**Z-59
(2015)**

DATE	DESCRIPTION							ART FRAMES 115 STEVENSON STREET, SUITE 200 ATLANTA, GA 30308 PHONE: 770-454-1100	ZONING SITE PLAN ART FRAME EXPANSION LAND LOT 41, DISTRICT 18, 2ND SECTION COBB COUNTY, GEORGIA	SHEET NO. C20 OF 2
			DATE	DESCRIPTION									
PROJECT NO. Z-59 DATE: 07/24/2015

ZONING COMMENTS:

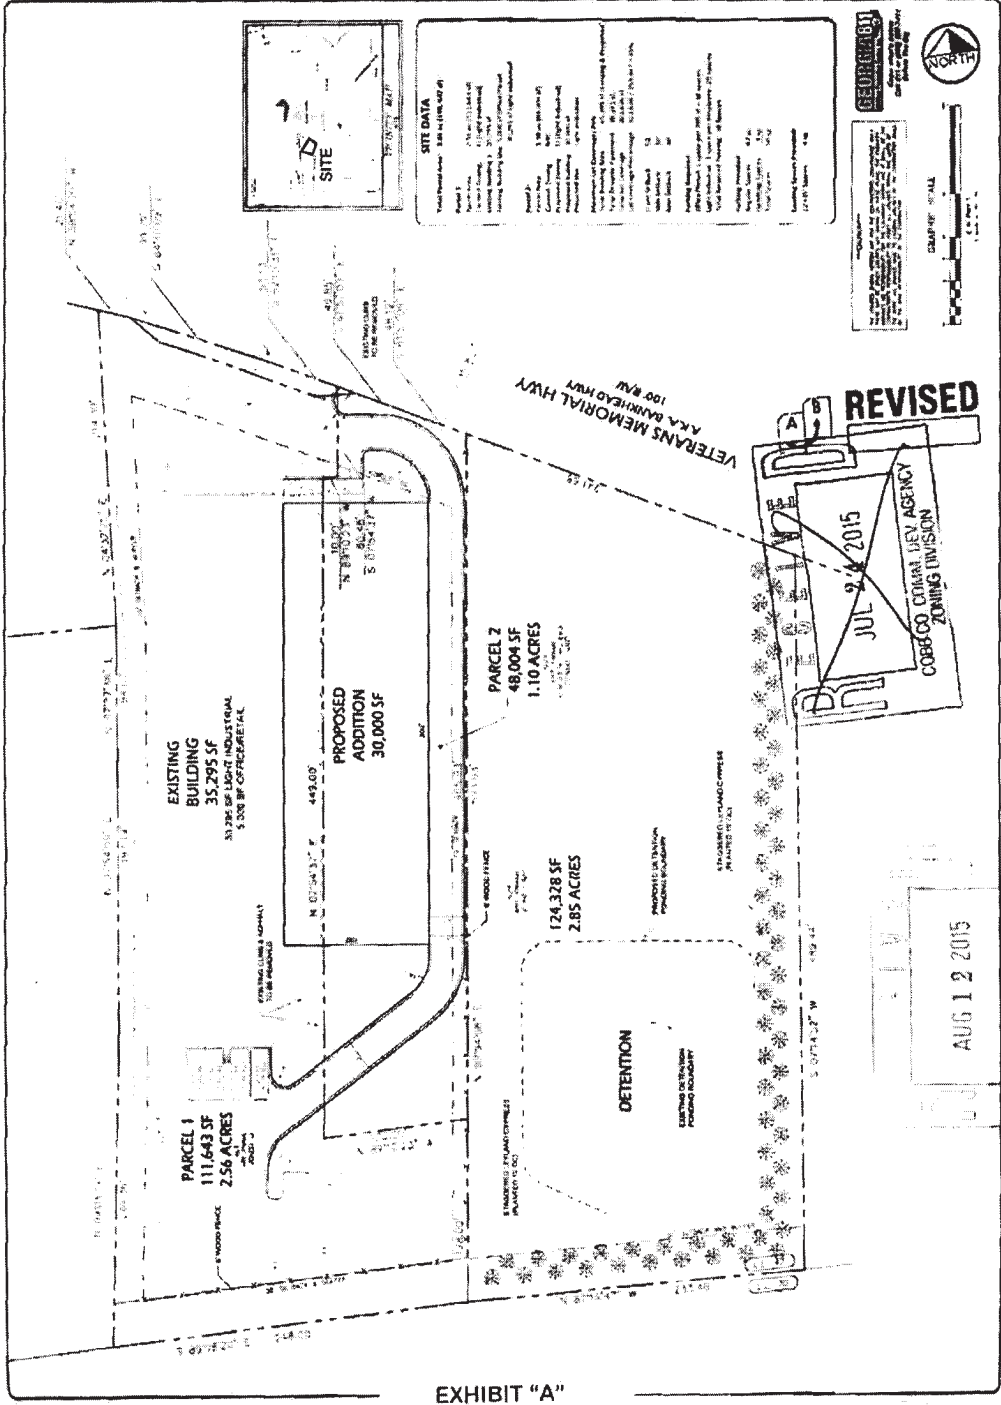
- Provide comprehensive hydrology/stormwater controls to include development of out parcels.
- Submit all proposed site improvements to Plan Review.
- Any **spring activity** uncovered must be addressed by a qualified geotechnical engineer (PE).
- Structural fill _____ must be placed under the direction of a qualified registered Georgia geotechnical engineer (PE).
- Existing facility.
- Project must comply with the Water Quality requirements of the CWA-NPDES-NPS Permit and County Water Quality Ordinance.
- Water Quality/Quantity contributions of the existing lake/pond on site must be continued as baseline conditions into proposed project.
- Calculate and provide % impervious of project site.
- Revisit design; reduce pavement area to reduce runoff and pollution.

- No Stormwater controls shown _____
- Copy of survey is not current – Additional comments may be forthcoming when current site conditions are exposed.
- No site improvements showing on exhibit.

1. Applicant must verify that adequate stormwater management is provided within the existing master detention facility or redesign to accommodate the proposed site expansion.

- Revised site plan received by the Zoning Division on August 12, 2015 with District Commissioner approving minor modifications;
- Use specific for retail and wholesale framed art business; any change in use to be approved by the District Commissioner;
- District Commissioner approve building architecture;
- Water and Sewer Division comments and recommendations;
- Stormwater Management Division comments and recommendations;
- Fire Department comments and recommendations;
- Department of Transportation comments and recommendations.
